BPDA Design Review Provisos 1149 Harrison Avenue, Roxbury Neighborhood Design Review 9/5/23

NEW CONSTRUCTION MIXED USE DWELLING 1149 - 1155 HARRISON AVENUE, WARD 08

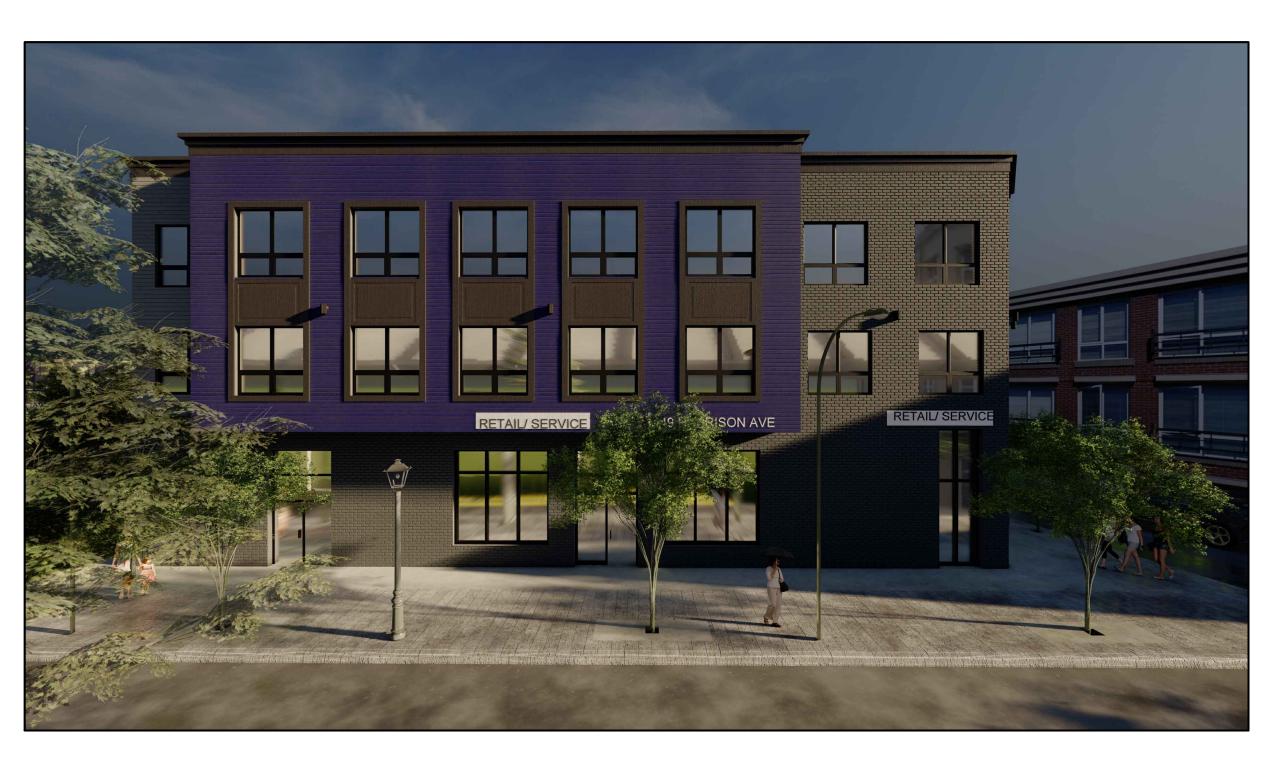
- 4. An updated certified plot plan shall be submitted to the BPDA for review and approval.
- 5. Curb-cuts should be limited to 10ft wide for residential projects, and 20ft wide for commercial projects. The pedestrian sidewalk must be continuous over the access driveway.
- 6. All new trees shall be a minimum 3" in caliper.

Building

PROPOSED VIEW FROM REAR SCALE: N/A

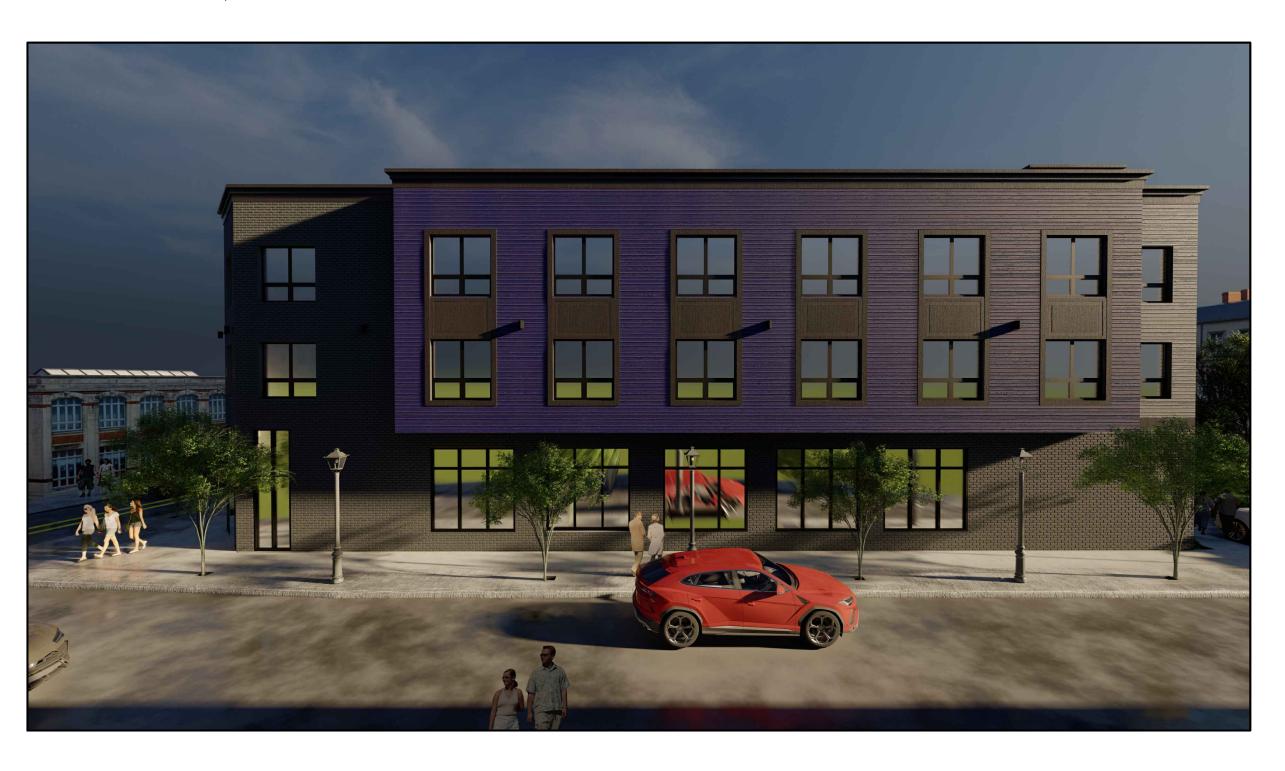
8. The final location of the HVAC compressors, gas meters, electric meters, generators, switchgear, and transformers shall be adequately screened from public view and will not be allowed in the front yard.

9. All mechanical vents shall be through the roof or rear wall and shall not be visible from the public street. Vents located on elevations that do not directly face a public way should be composed on the facade so as to minimize their appearance.
